[Docket No. FAA-2020-1120; Project Identifier 2019-SW-056-AD]

**Airworthiness Directives; Goodrich Externally-Mounted Hoist Assemblies**

**ACTION:** Supplemental notice of proposed rulemaking (SNPRM).

Figure 1 to Paragraph (g)(2)(i)

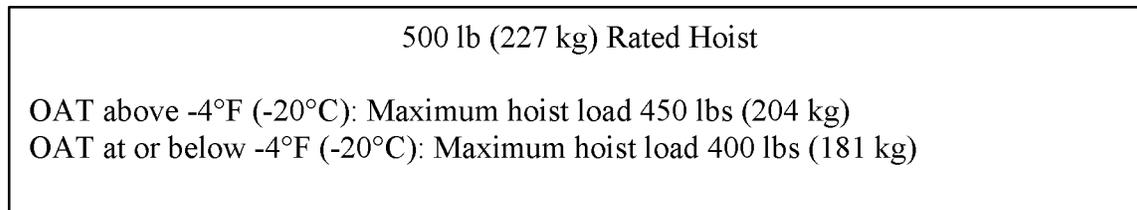
In this SNPRM, the FAA has added “total” to the compliance time and usage thresholds for hoists without a “4” as the first digit of its S/N to clarify that it is the total accumulation of time on the hoist that would trigger the proposed requirement to replace the hoist. In this SNPRM, the FAA has also added the metric conversion (kg) for the hoist ratings in the first two figures.

(i) For 500 pound (lb) rated hoists, install a placard with the information in Figure 1 to paragraph (g)(2)(i) of this AD in full view of the hoist operator and add the information in Figure 1 to paragraph (g)(2)(i) of this AD to the existing RFM for your helicopter:
